# Work Order ID 98188

Item Name: Crosstube Assembly, Mid Fwd

<b>DART AEROSPACE LTD</b> HAWKESBURY, ONTARIO, CANADA	
DRAWING NO. D206-667-147	REV. A SHEET 1 OF 4
TITLE CROSSTUBE ASS'Y (206L MID FWD)	SCALE NTS

DRAWING NO. D206-667-147	TITLE CROSSTUBE ASS'Y (206L MID FWD)	REV. A	<b>DART AEROSPACE LTD ENGINEERING ORDER</b>		D.E.O. NO. D206-667-147-A-1	SHEET NO. SHEET 1 OF 1	SCALE NTS
DRAWN <i>q</i>	CHECKED <i>ASS</i>	MFG. APPR. <i>JB</i>	APPROVED <i>MD</i>		DE APPR. <i>MD</i>		
DATE 11.07.15	DATE 11.07.20	DATE 11.07.21	DATE 11/07/21		DATE 11.07.21

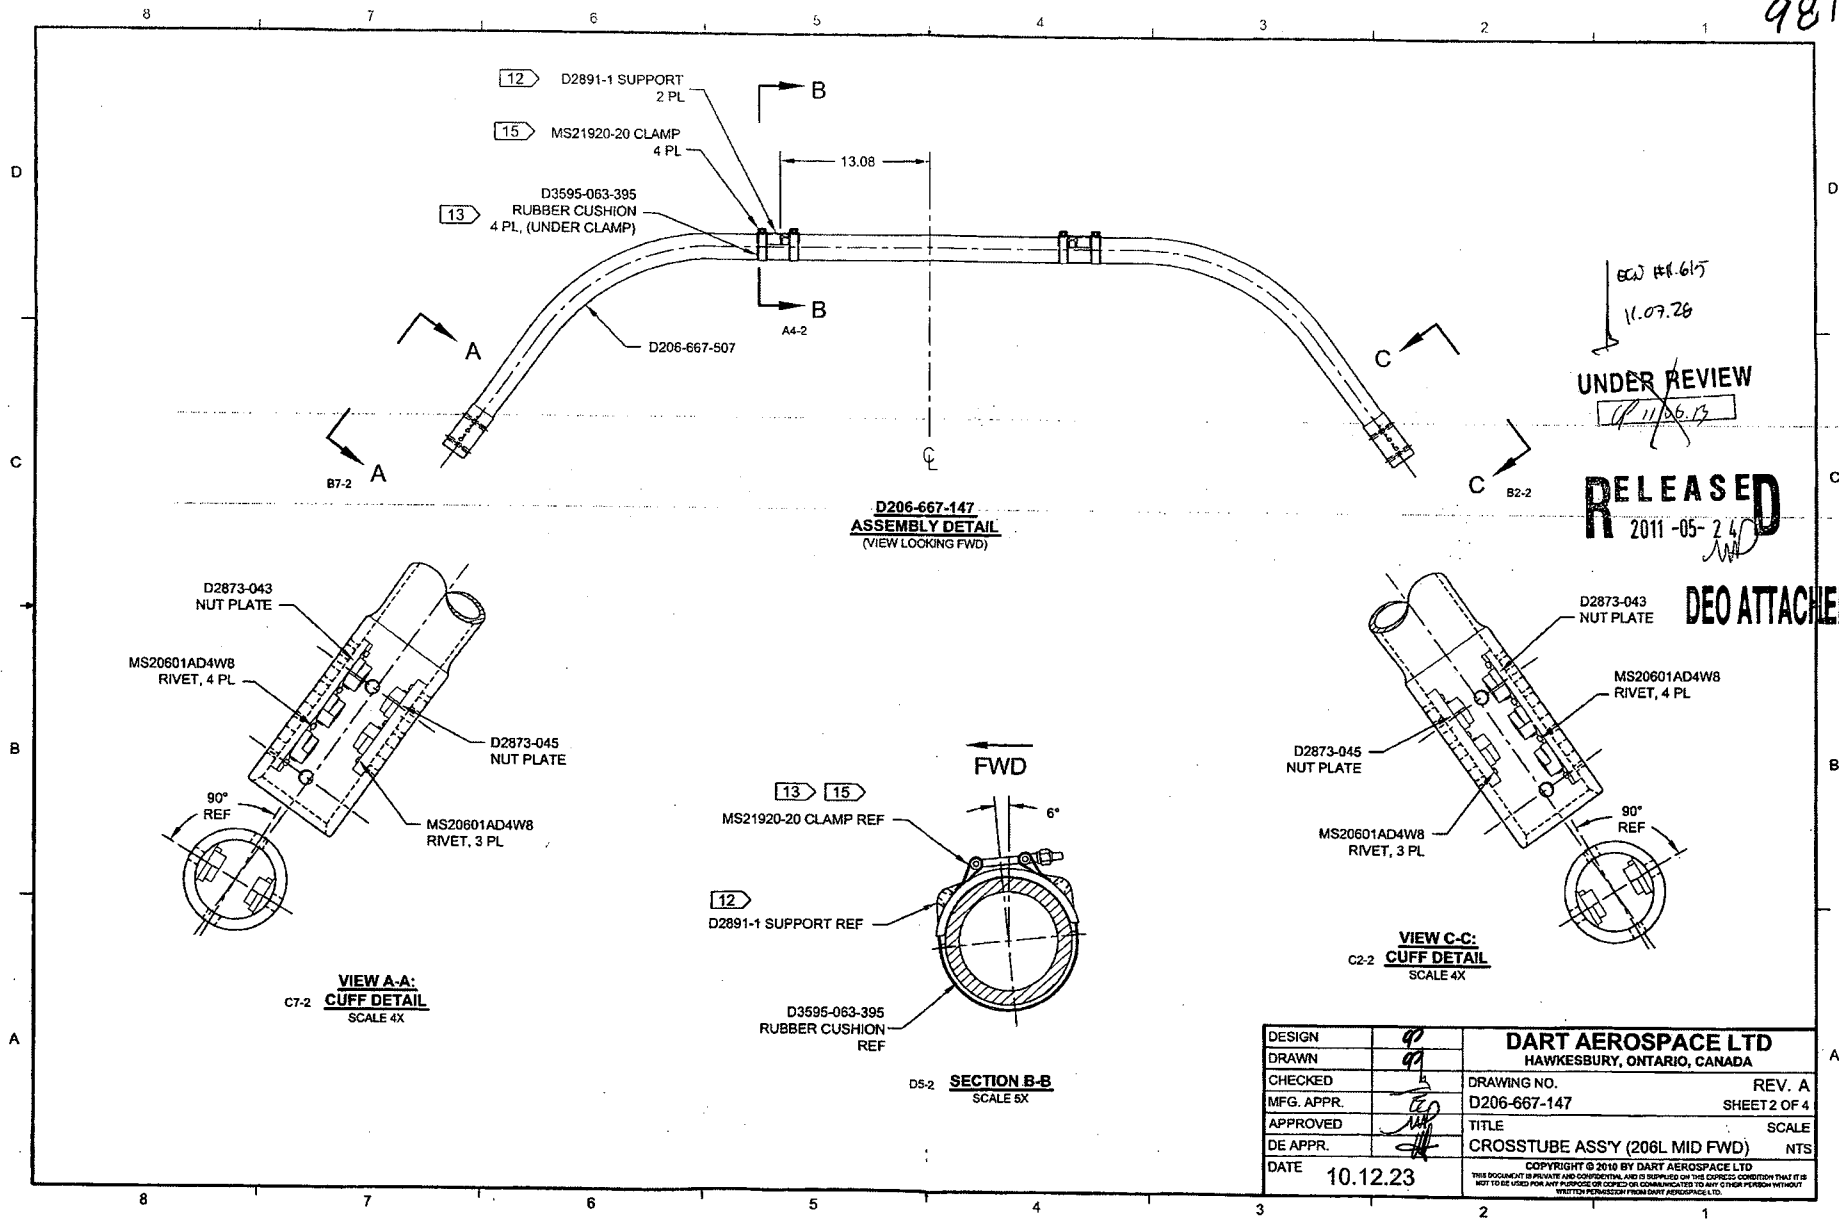
**PURPOSE:**

REPLACE MAGNOBOND WITH PROSEAL.

**CHANGE:****IS:**

Item	Qty -147	Part Number	Description
9	A/R	PROSEAL 890 B-2	SEALANT, AMS-S-8802 CLASS B-2

**WAS:**

9	A/R	MAGNOBOND 6398	ROCKWELL SPECIFICATION RBO-120-023 ADHESIVE (TEXTRON/BELL SPEC. 299-947-100, TYPE II, CLASS 2 ADHESIVE)
---	-----	----------------	---

NOTE 12 &amp; 15, SHEET 1 IS AMENDED AS FOLLOWS:

**IS:**

- 12) TO INSTALL D2891-1 SUPPORT: ABRASE MATING SURFACE OF SUPPORT AND CROSSTUBE WITH 180-GRIT SANDPAPER AND REMOVE RESIDUE WITH MEK (OR EQUIVALENT). APPLY A 0.04" TO 0.07" THICK LAYER OF PROSEAL 890 CLASS B-2 (OR AMS-S-8802 CLASS B-2) SEALANT TO MATING SURFACE OF SUPPORT.
- 15) TORQUE CLAMPS 80 TO 100 IN-LB. ENSURE AT LEAST 1.5 THREADS SHOWING IN SAFETY AND THAT NUT HAS NOT BOTTOMED-OUT AFTER TORQUING. **PRIOR TO PACKAGING, RE-CHECK TORQUE ON CLAMPS AFTER PROSEAL 890 SEALANT HAS CURED FOR 72 HOURS.**

**WAS:**

- 12) INSTALL D2891-1 SUPPORT USING 0.03" TO 0.06" THICK LAYER OF MAGNOBOND 6398 PER QSI 015. LET CURE FOR 12 HOURS AFTER INSTALLATION AND PRIOR TO PACKAGING.
- 15) TORQUE CLAMPS 80 TO 100 IN-LB. ENSURE AT LEAST 1.5 THREADS SHOWING IN SAFETY AND THAT NUT HAS NOT BOTTOMED-OUT AFTER TORQUING.

**SECTION R-R**

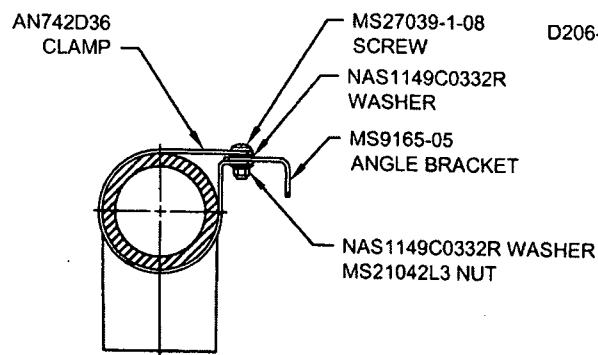
**PURPOSE:**

ADD ELECTRICAL GROUNDING STRAP

ITEM	QTY -147	PART NUMBER	DESCRIPTION
1	X	D206-667-147	CROSSTUBE ASSEMBLY (206L MID FWD)
10	2	AN742D36	CLAMP
11	2	MS9165-05	ANGLE BRACKET
12	2	MS21042L3	NUT (OR MS21042-3)
13	2	MS27039-1-08	SCREW
14	4	NAS1149C0332R	WASHER (OR AN960C10L)

ADD

**GENERAL NOTES:**

- 16) MASK AREA UNDER CLAMP PRIOR TO PAINTING  
 17) SEAL EDGES WHERE AN742D36 CLAMP MEETS WITH THE CROSSTUBE USING SIKAFLEX-241/-291 OR MIL-S-8802 CLASS B2 OR PROSEAL 890 SEALANT  
 18) PERFORM RESISTANCE CHECK TO ENSURE MAX RESISTANCE IS 10 MILLIOHMS
